**ADDENDUM No. 1**

**Lincoln and Adams Elementary Schools 2024 Kitchen Upgrades**

Arch. Project #220117

## ADDENDUM NO. 1

### A1.3

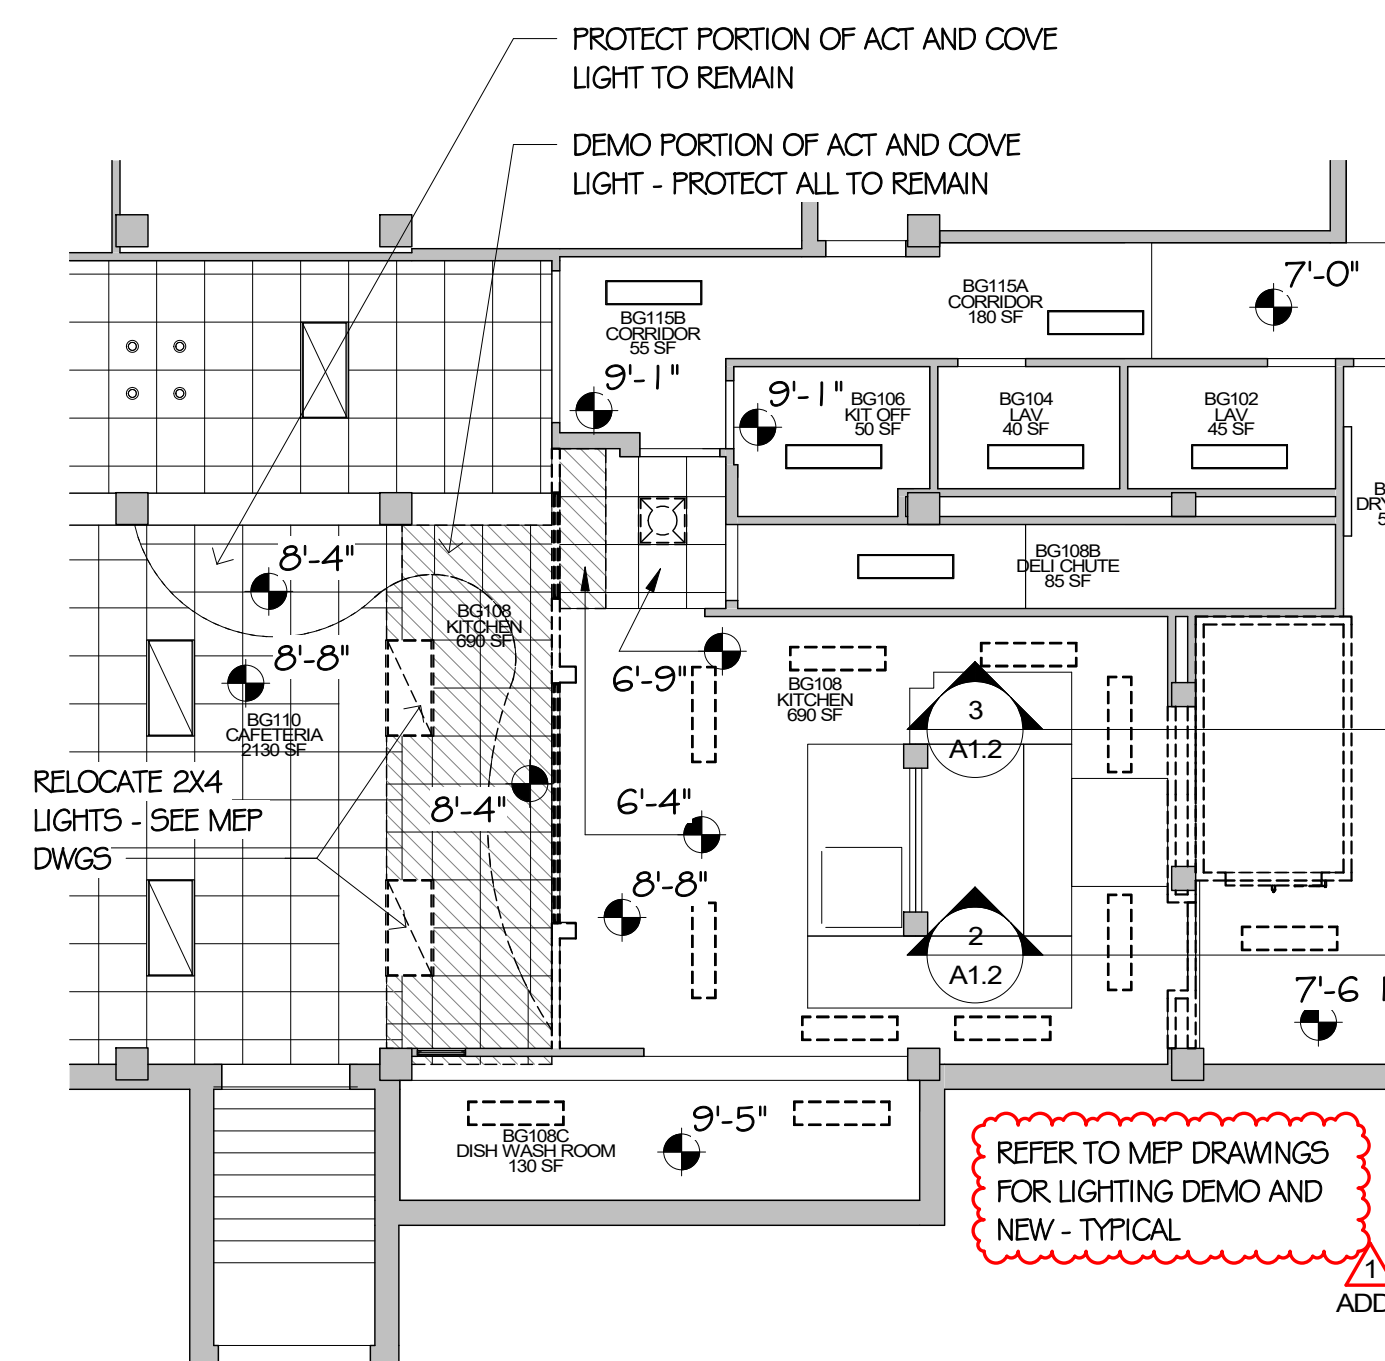
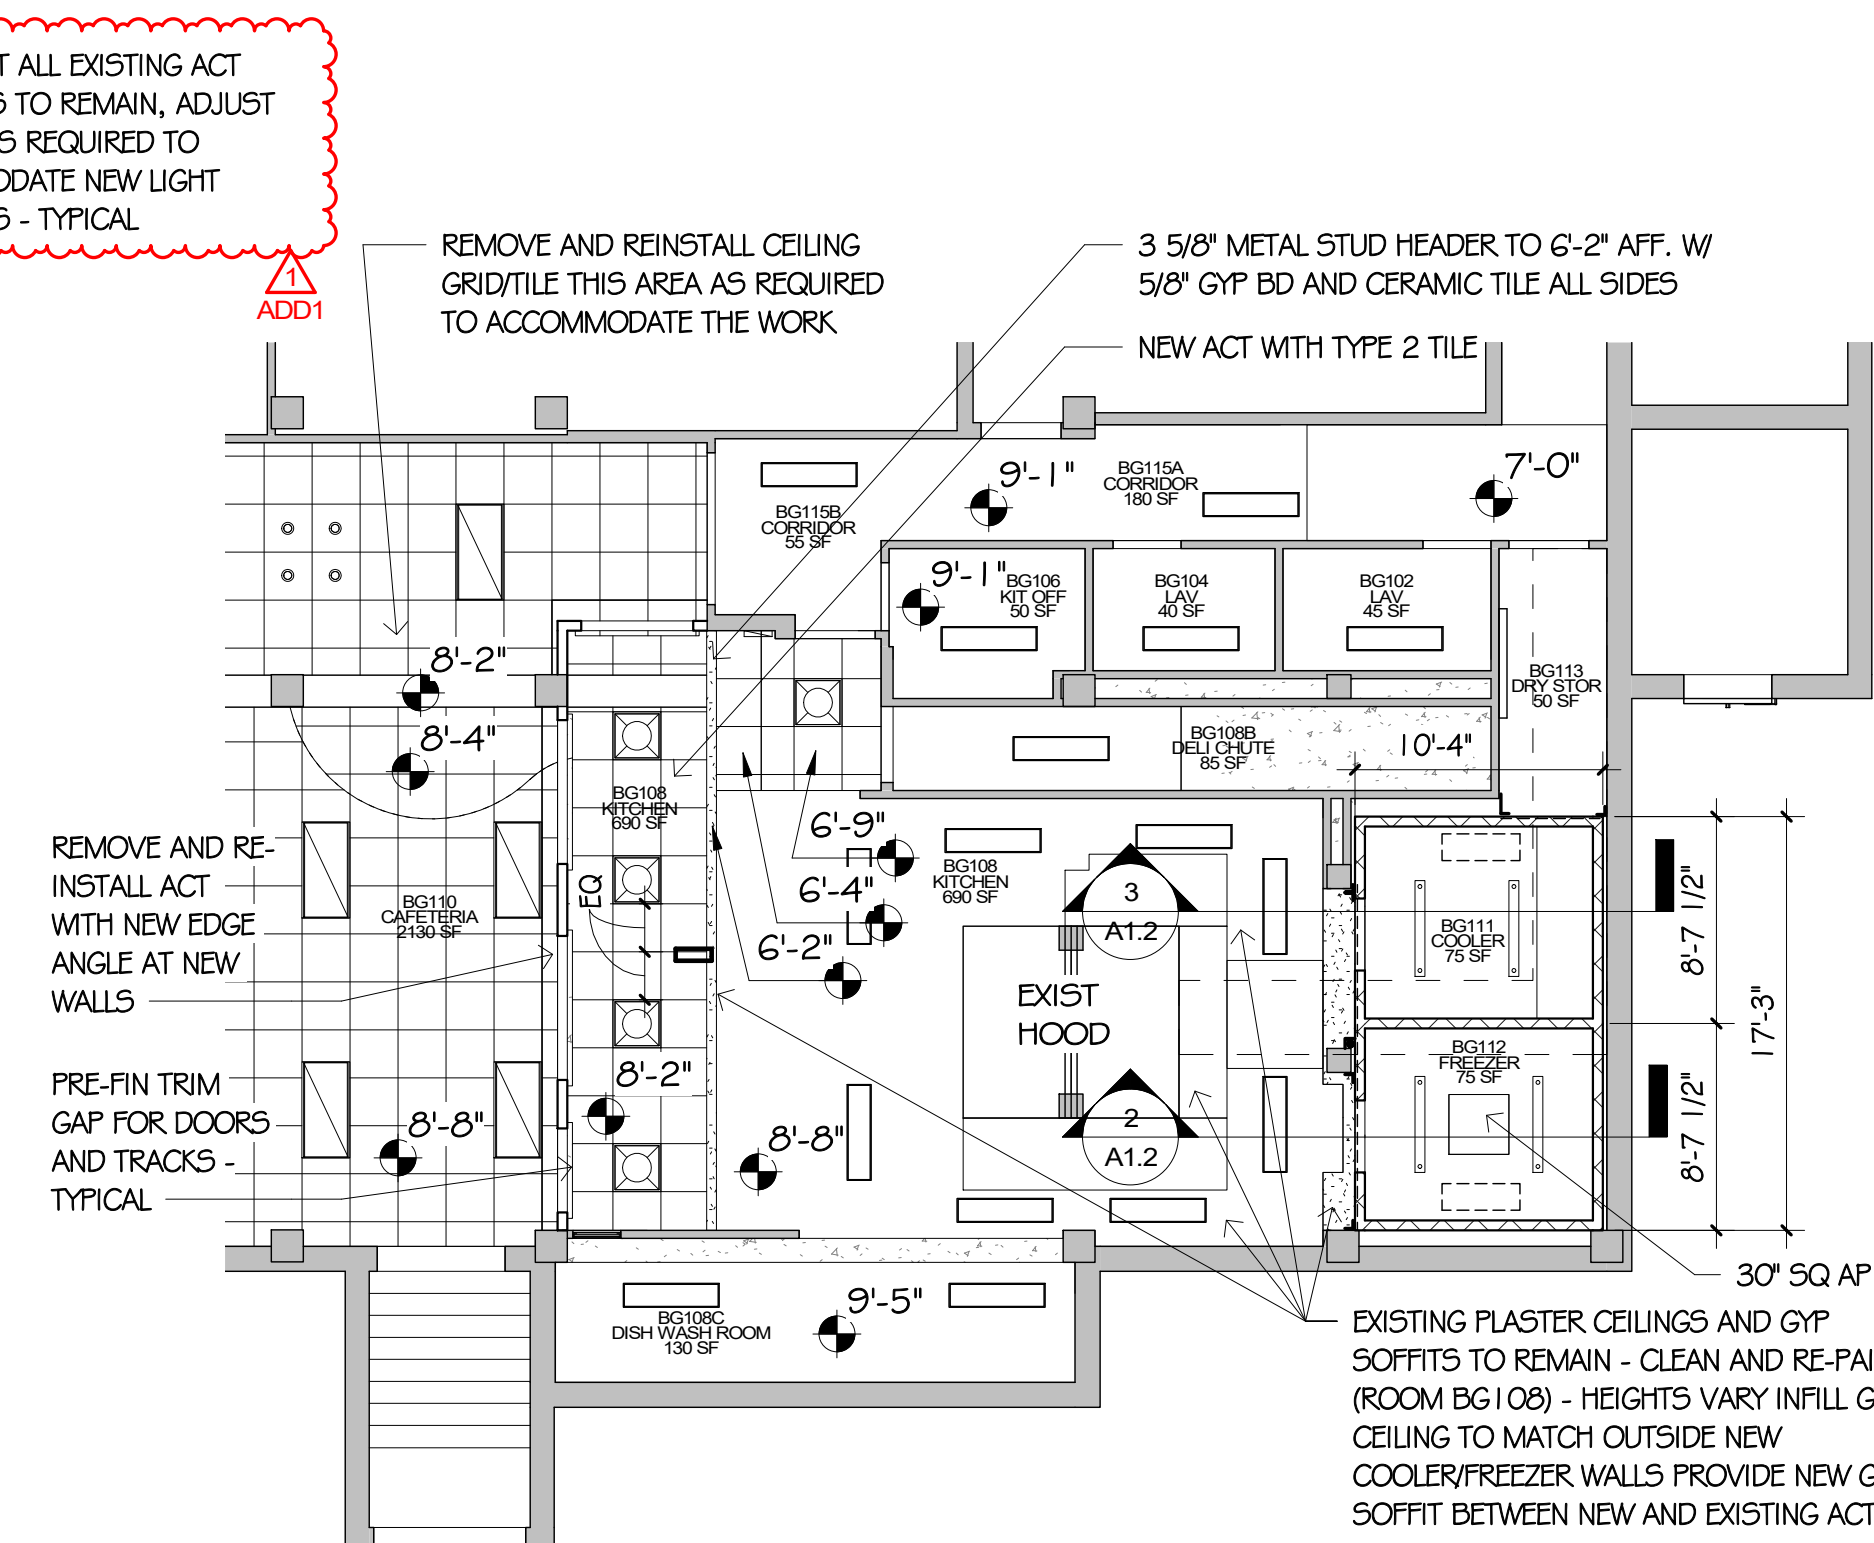
**Item 4 Sheet A1.3:** Add note to adjust existing ACT grids as required for new lighting layout. Existing and New lighting updated to match MEP drawings.
